## Editors' Notes

### A READER COMMENTS

Last fall, we published an [article](#) about adding stereo audio to a satellite set-top box. The key idea was to apply a phase-locked loop, with the vestigial 15.734-kHz pilot signal in the composite spectrum as the reference, allowing one channel of the [AD71028](#) BTSC encoder to derive the primary channel's master clock while the other channel provides the MTS stereo-encoded output for satellite set-top boxes and receivers.

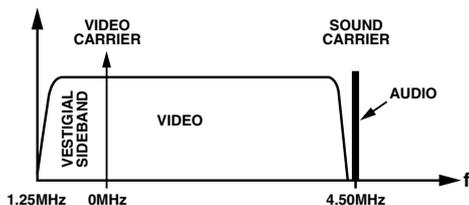
"I found your design using the AD71028 as a STB (satellite set-top box) stereo synthesizer clever and interesting. However, I can suggest two corrections to the information in the article. One is the RF spectrum of a modulated NTSC video and audio signal. It appears in your article as the following:

The frequency information may be misleading to a reader not familiar to the standard. More commonly, the audio carrier frequency is measured relative to the channel carrier frequency or the video carrier frequency. The audio subcarrier would be 4.5 MHz. It is more intuitive to view the spectrum as seen below:

Your two clarifications are very valid. The first one was likely an interpretation by the graphic designer, as the original intended figure would have matched Fig. 2 in this document <http://www.sencore.com/custsup/pdf/TT213.pdf>
